ADDENDUM NO. 1

POLYTECH HIGH SCHOOL
RENOVATIONS AND ADDITIONS
BID PACKAGE 'A'

This addendum is hereby made part of the Project Manual and Drawings dated 9 July 2012.

CSK015

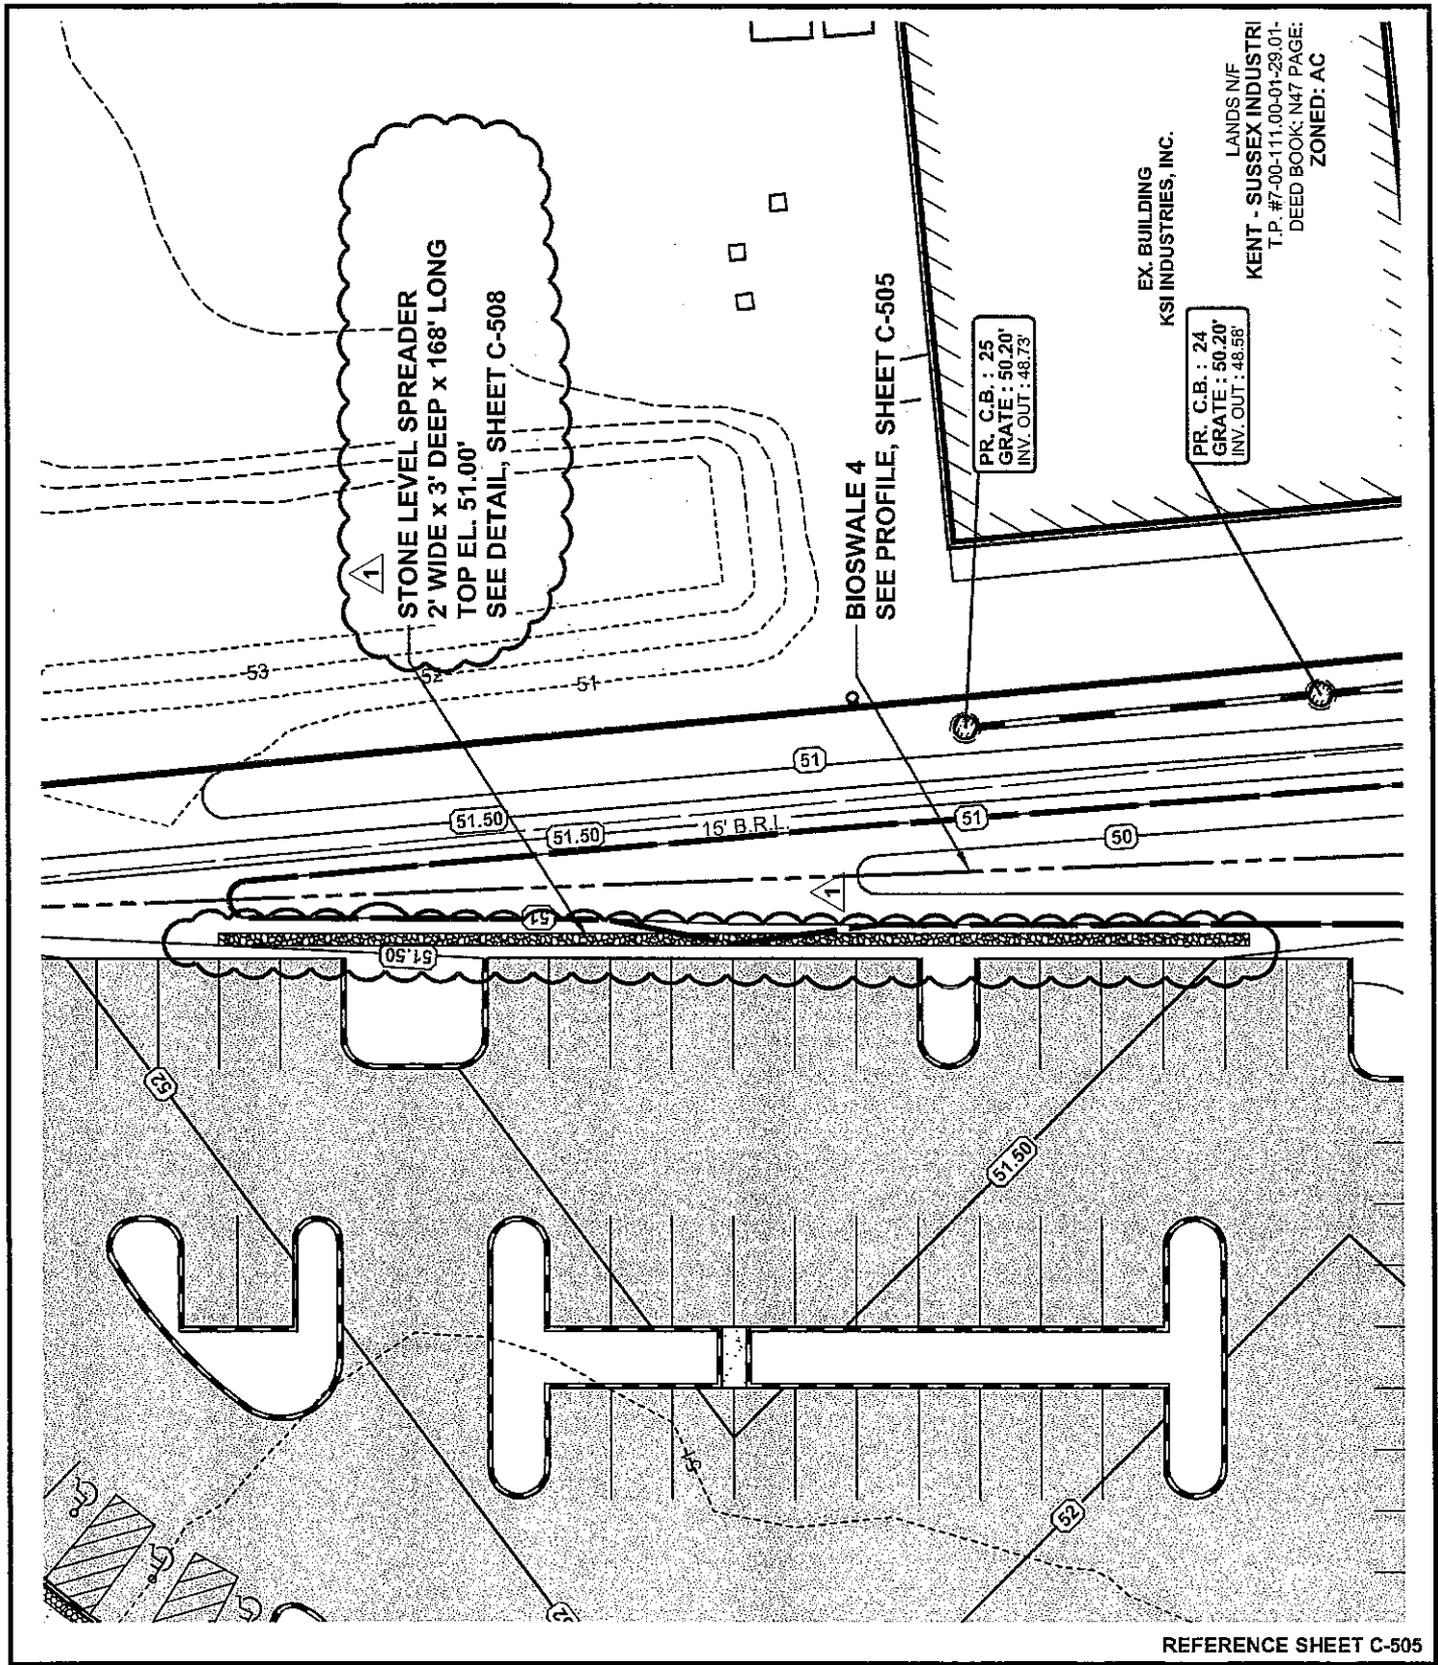
- K. **C-501 Sediment and Stormwater Management Plan** - Drawing revised as indicated on sketch CSK013 and included with this addendum.
- L. **C-504 Sediment and Stormwater Management – Bioswale 1, 2 and 3 Plan, Profile & Section and Constructed Wetland Section** - Drawing revised as indicated on sketches CSK014 and CSK015 and included with this addendum.

CSK017

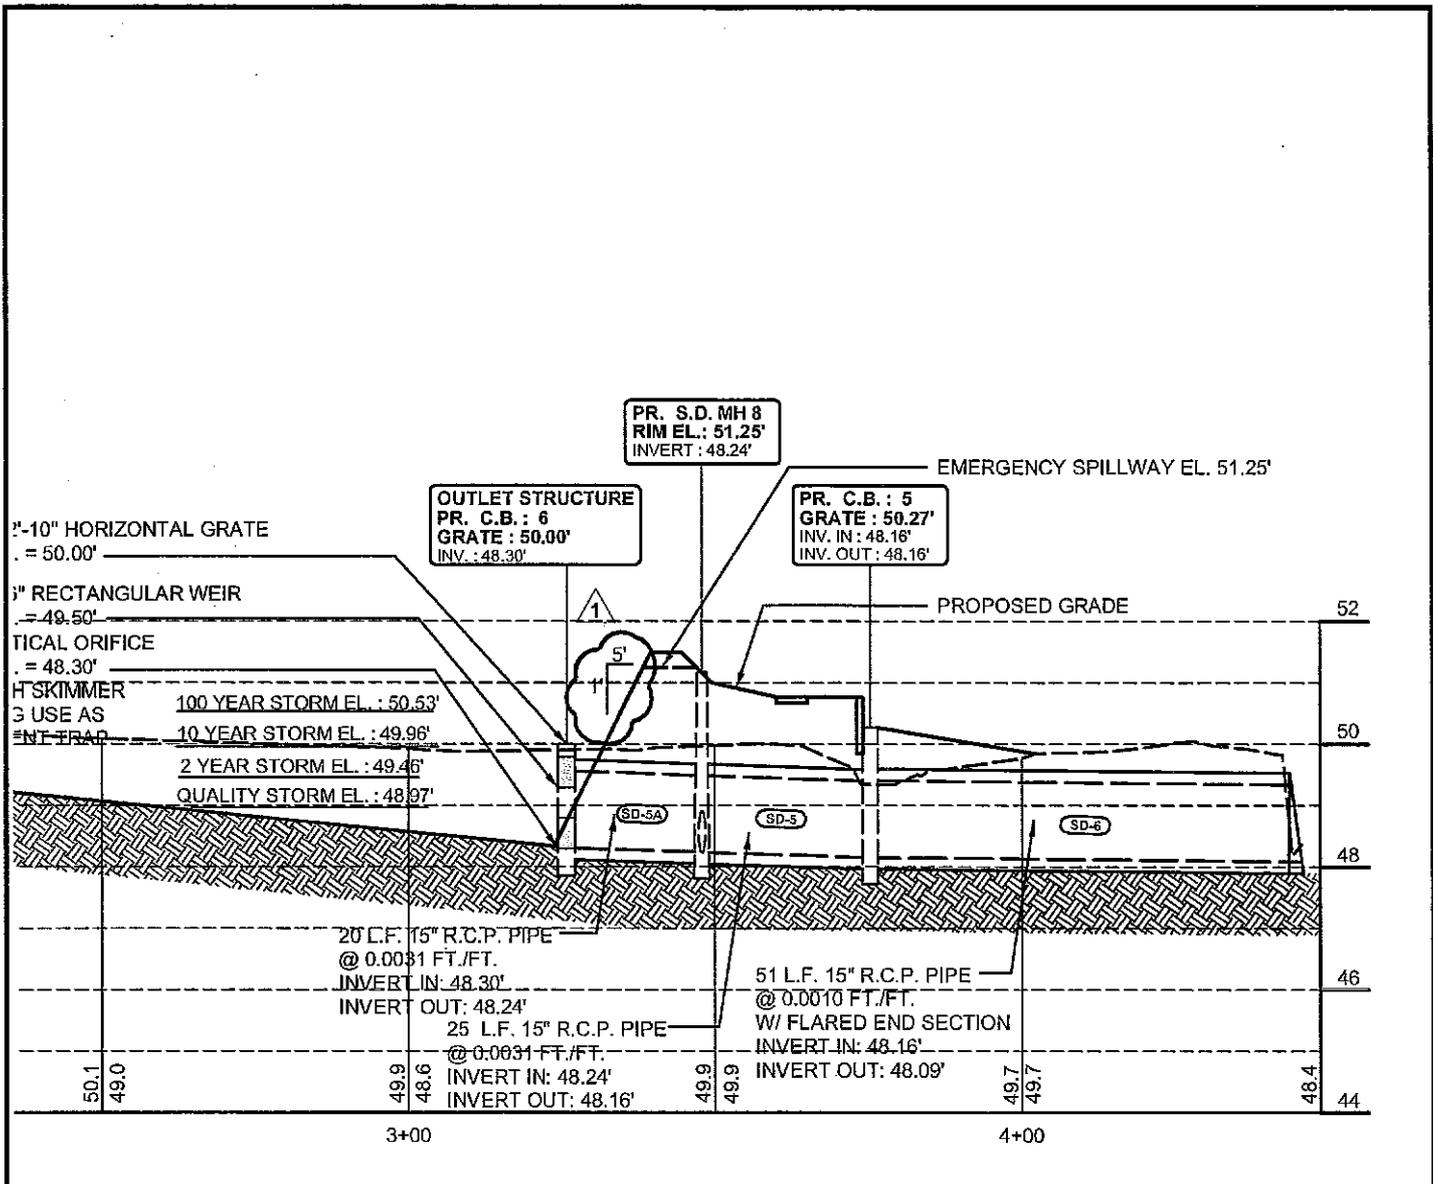
- M. C-505 Sediment and Stormwater Management – Bioswale 4 Plan, Profile & Section, S.W.M. Section & Outlet Structure CB-6 Detail** - Drawing revised as indicated on sketches CSK016, CSK017, CSK018, CSK019, CSK020, CSK021, and CSK022 and included with this addendum.

CSK020

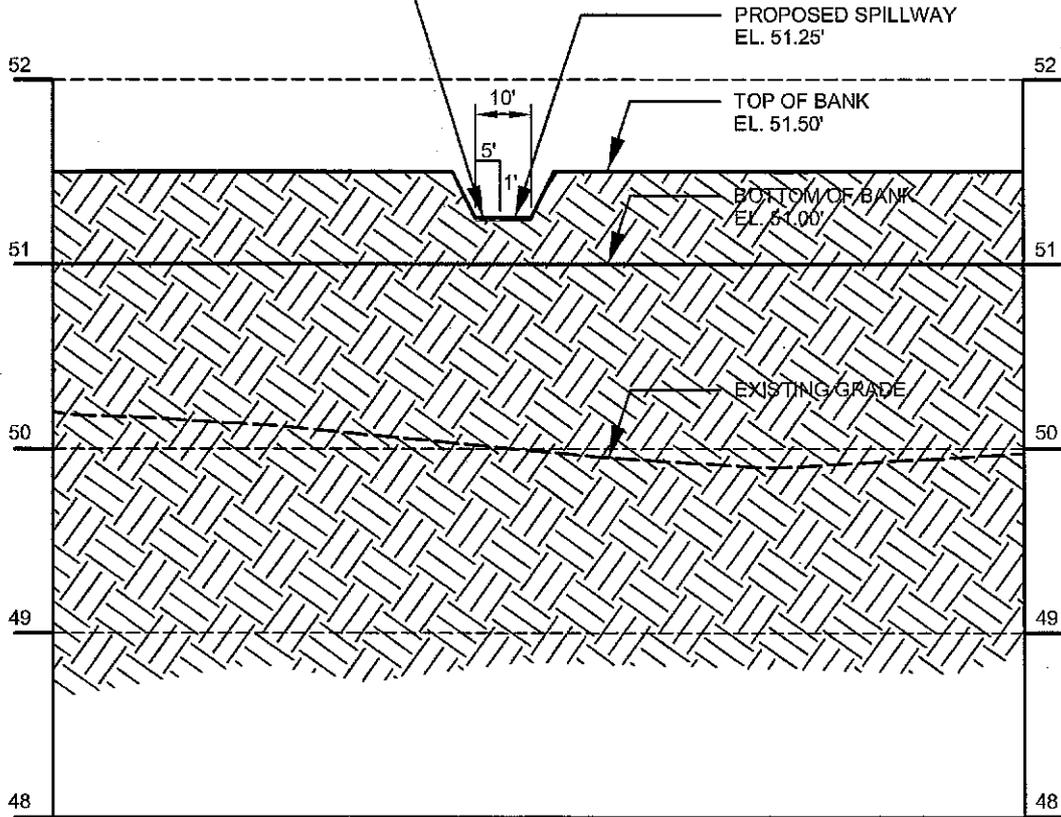
PLACE TURF REINFORCEMENT
MATTING ON SPILLWAY

CSK023

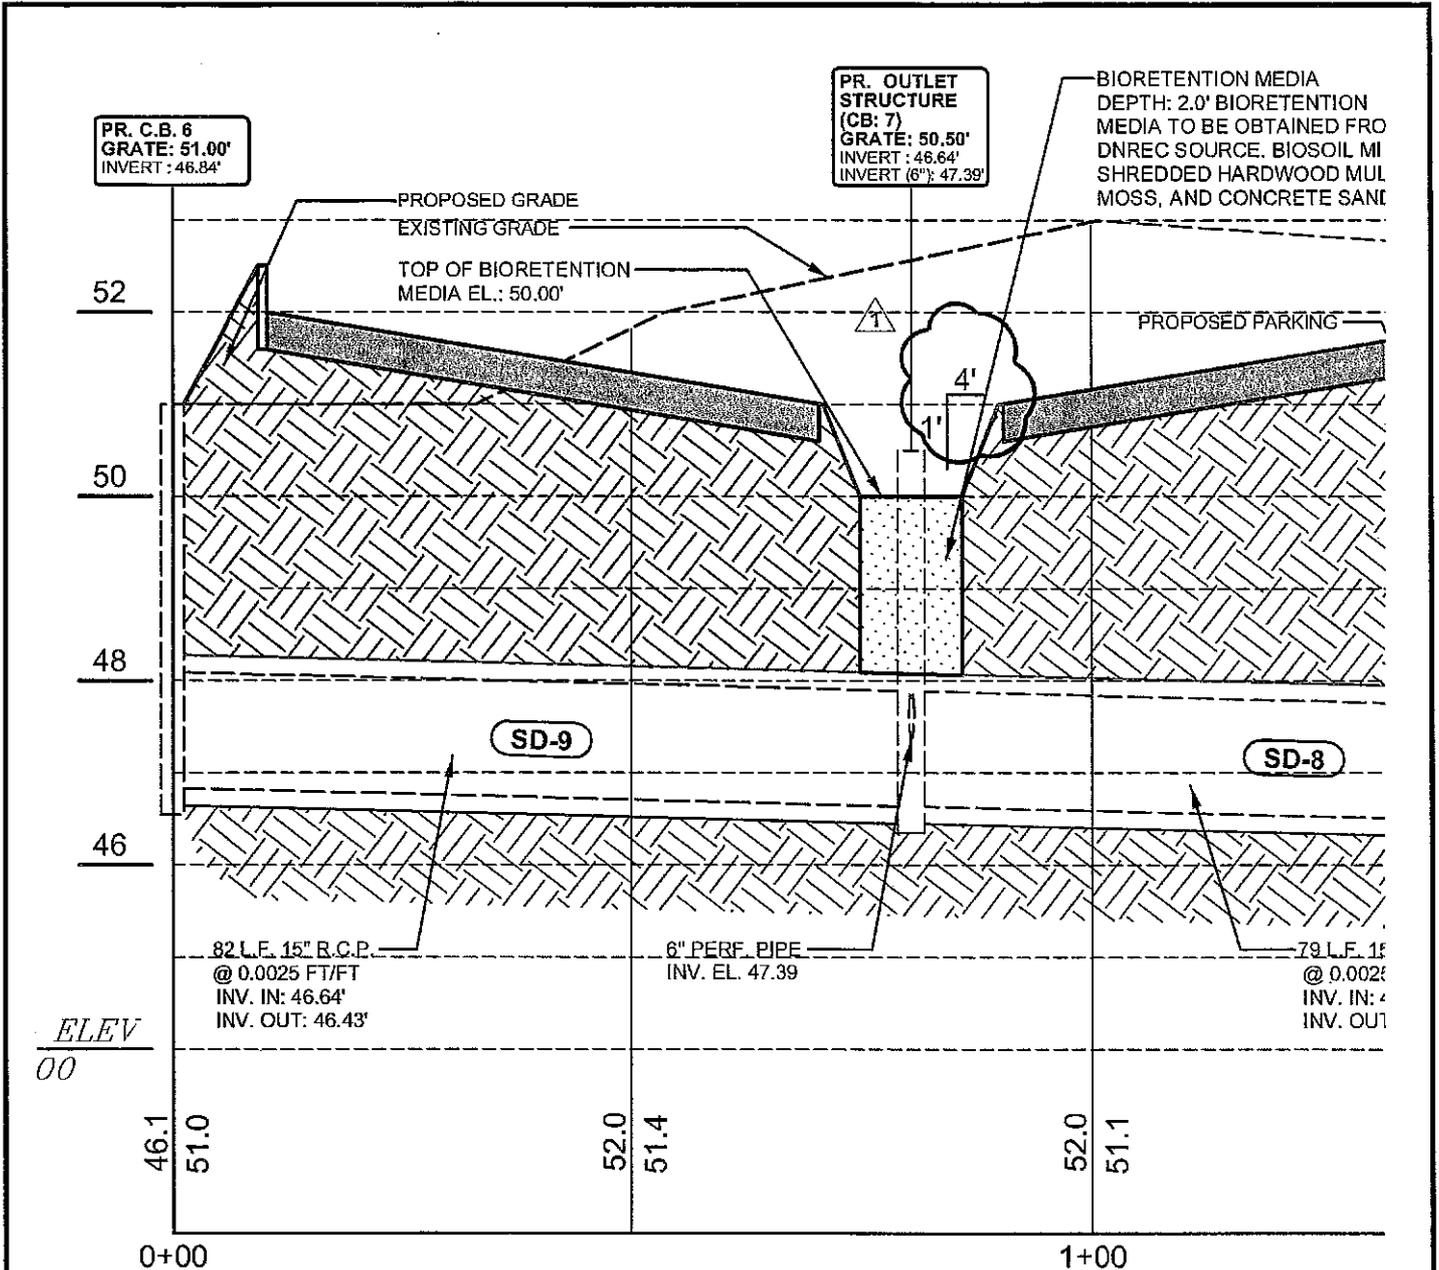
- N. C-506 Sediment and Stormwater Management – Bioretention Plan & Sections and Existing S.W.M. Pond Plan, Section and Details.** - Drawing revised as indicated on sketches CSK023 and CSK024 and included with this addendum.

CSK026

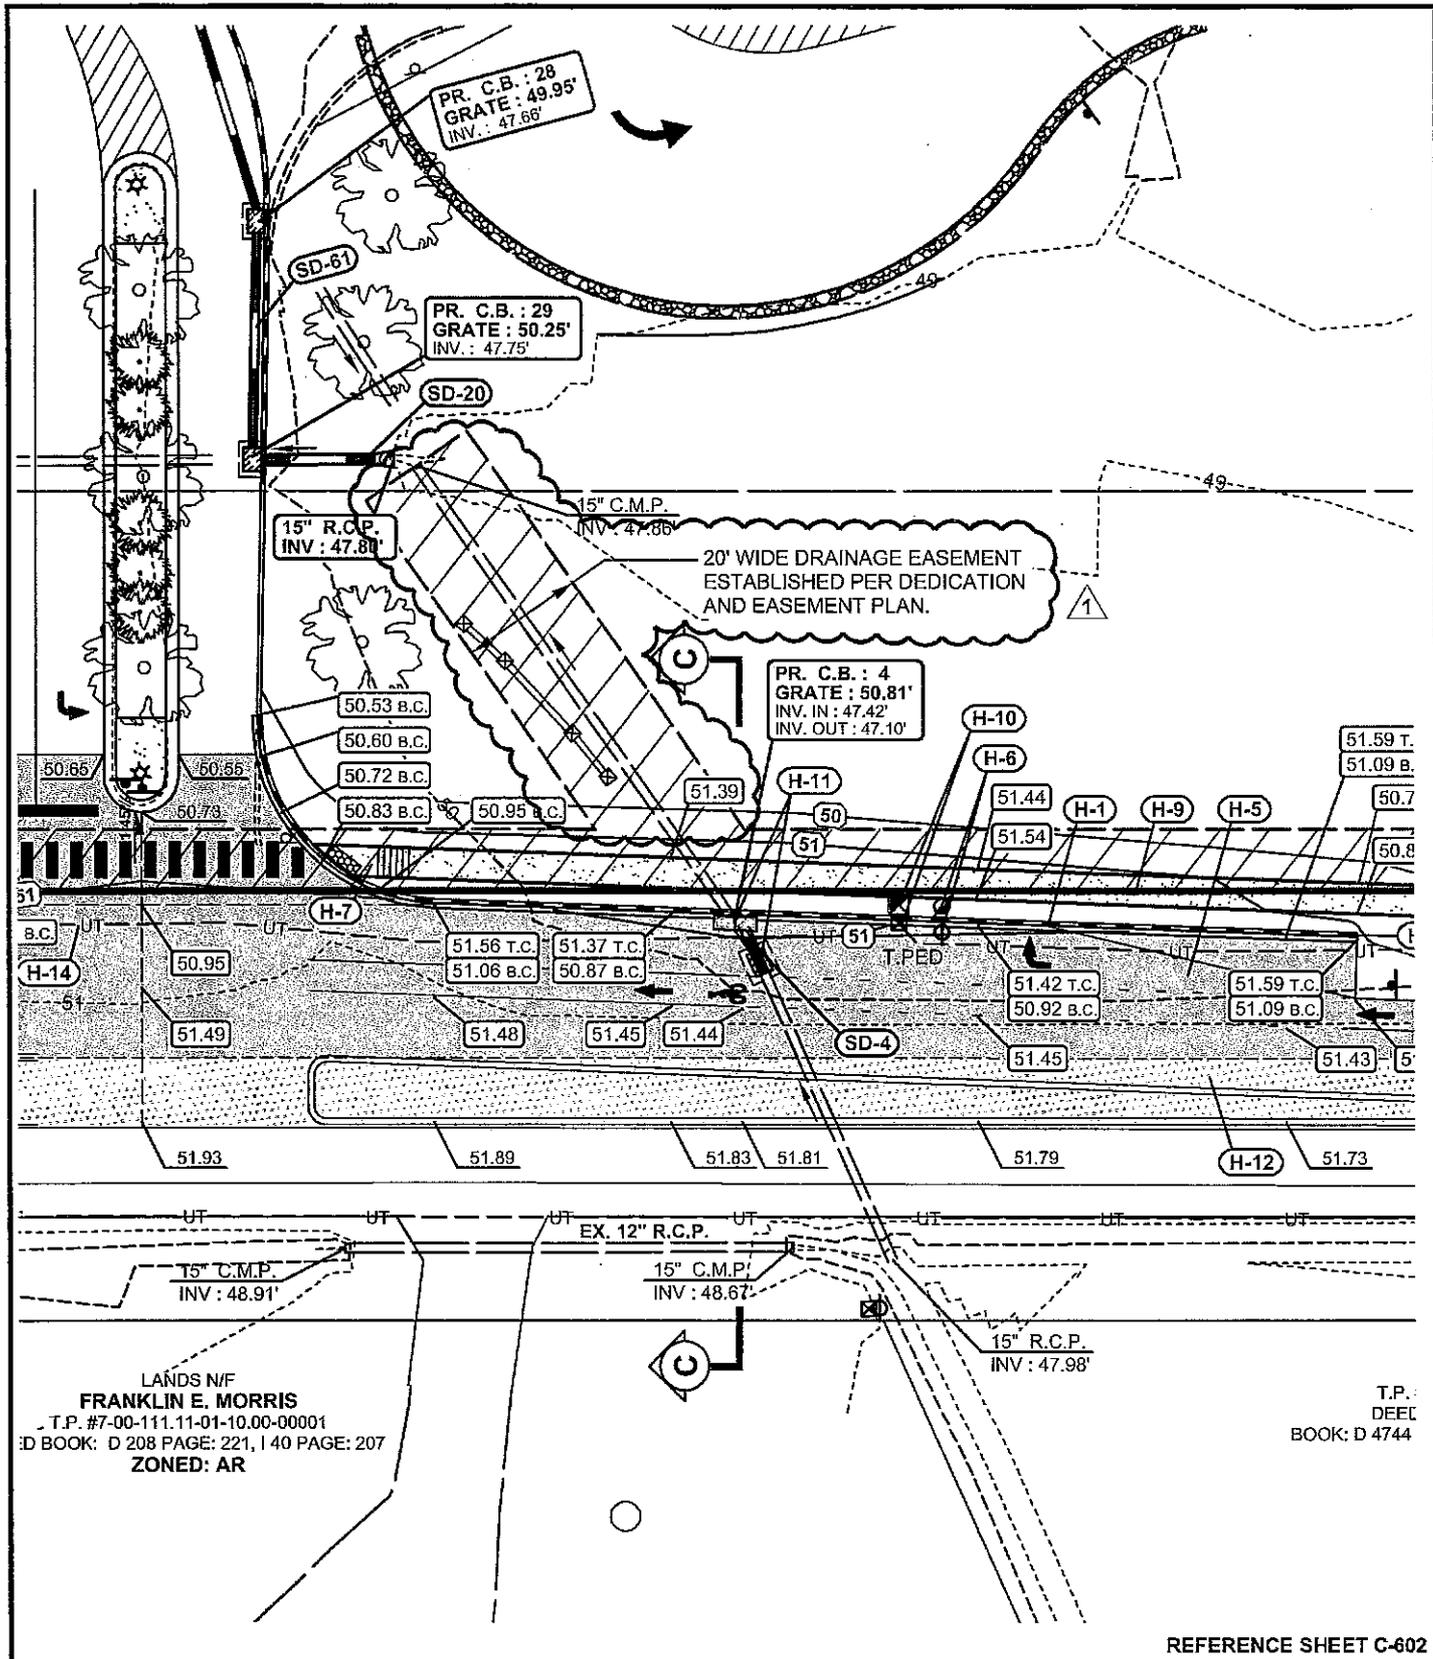
- O. C-601 Entrance Signage and Striping Plan** - Drawing revised as indicated on sketches CSK025 and CSK026 and included with this addendum.
